# UNITED STATES PATENT AND TRADEMARK OFFICE

APPLICATION NO.	FILING DATE	FIRST NAMED INVENTOR	ATTORNEY DOCKET NO.	CONFIRMATION NO.
10/696,035	10/30/2003	Akira Muroi	SWA-0001	6030

<b>Office Action Summary</b>	Application No. 10/696,035	Applicant(s) MUROI ET AL.	
	Examiner Aaron M Dunwoody	Art Unit 3679

## **DETAILED ACTION**

Fig 4A

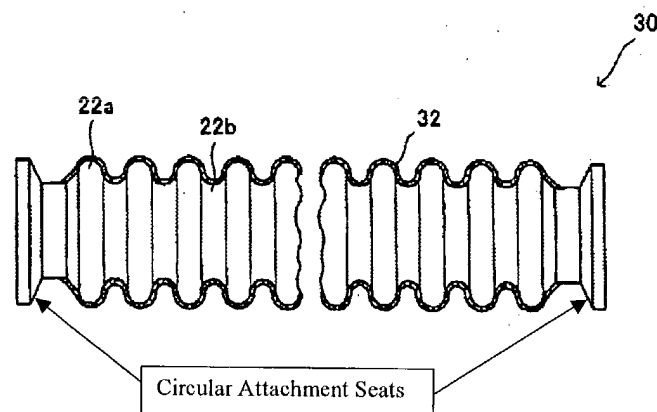
In regards to claim 3, in Figure 4A below, Takaara discloses each of both ends of the metal pipe being provided a circular attachment seat with its section being L-shaped and the attachment seat being engaged with and attached to the surface of the outer side and the inner circumferential surface.
